# Access Compliance Report

## Public Rights-of-Way

### (Curb Ramps)

Intersection ID: 44001	Main Street: ELROSE_PL	Cross Street: N/A	Location: SE
ADA ID: 4762123F23C3	Ramp Type: Perp	Initial Pass/Fail: Fail	Overall Compliance: No
Severity Score: 22.5			
Codes/Mitigation Info/Possible Solution		Field Measurements/Component Compliance

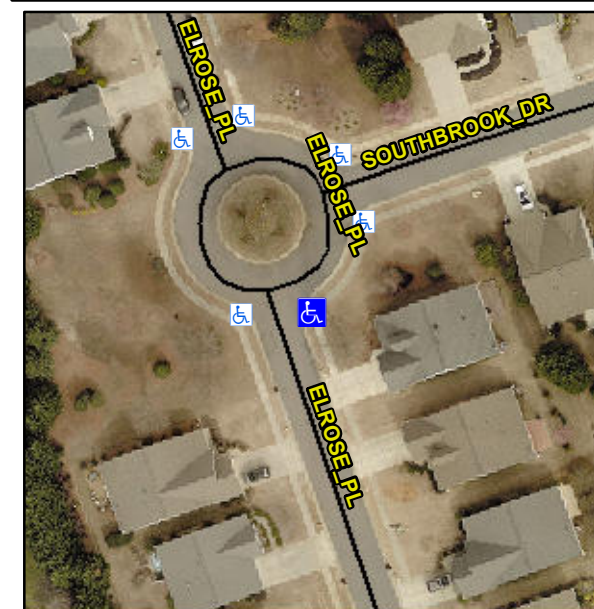
**Not Found, R304.5.1, R304.2.2, R304.5.3**

**Remove & Replace Entire Ramp.**
